Access Compliance Report Public Rights-of-Way (Curb Ramps)

Main Street: LORETTA_DR Cross Street: RAINIER_DR Location: SW

ADA ID: RPAT210930102356 Ramp Type: Type 1 - Perpendicular Diagonal Initial Pass/Fail: Pass Overall Compliance: No Severity Score: 20

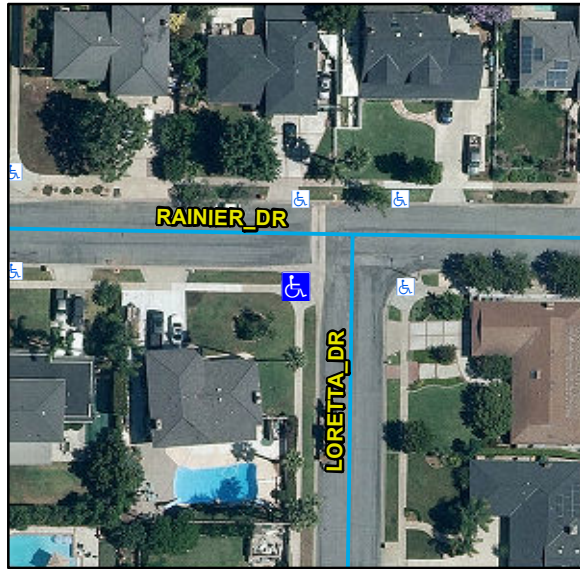
R204.3, R304.2.1, R304.2.2-Perp, R304.3.2-Para, R304.5.3, R305, STD 1115

Remove & Replace Curb Ramp With Two New Directional Ramps or Equivalent.
